# UNITED STATES PATENT AND TRADEMARK OFFICE

APPLICATION NO.	FILING DATE	FIRST NAMED INVENTOR	ATTORNEY DOCKET NO.	CONFIRMATION NO.
10/623,803	07/22/2003	Arnold Keller	246472005200	5304
7590	12/08/2005			
EXAMINER				RAMANA, ANURADHA
ART UNIT		PAPER NUMBER		
3733				DATE MAILED: 12/08/2005

<b>Office Action Summary</b>	Application No.	Applicant(s)
	10/623,803	KELLER, ARNOLD
	Examiner Anu Ramana	Art Unit 3733

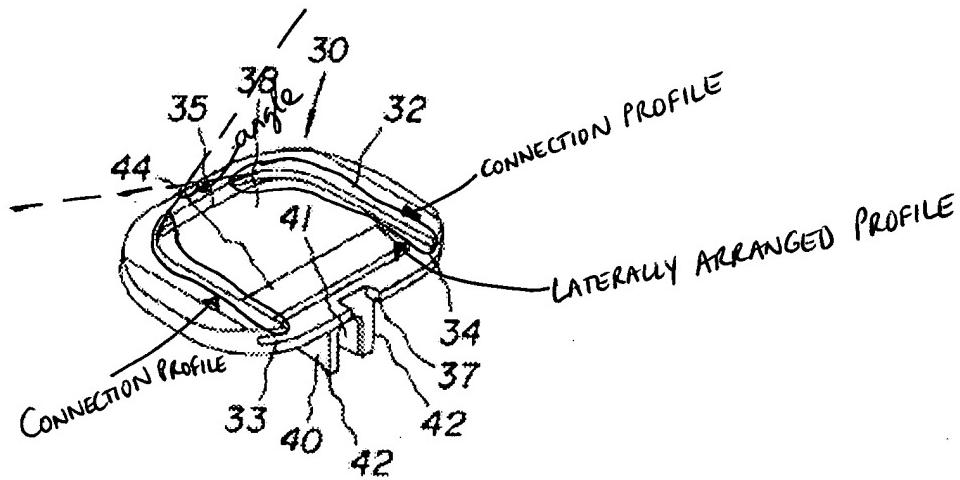
Marnay et al. disclose an intervertebral implant or prosthesis including two cover plates (11, 30) and a prosthesis core 50 wherein core 50 is connected to plate 30 by substantially straight undercut "connection profiles" that point generally inwardly or "are arranged" at an angle to one another wherein the angle is clearly not obtuse (Figs. 10, 11 and 13 and paras [0041] – [052]). See marked up Figure 10 on the following page.

Regarding claims 3 and 4, Marnay et al. disclose an engaging structure 44 arranged on a ventral side of the prosthesis having a pair of laterally arranged profile sections (see marked up Fig. 10 below).

Marnay et al. clearly disclose a pair of undercut substantially straight profile sections symmetric about an anterior-posterior direction wherein the profile sections are arranged at an angle to one another as discussed above. It is noted that "substantially straight" does not imply that the profile sections are completely straight. The recitation "an angle to one another" does not exclude a zero angle. Further, the reference axes for measurement of the recited "angle" is not defined in claim 1.
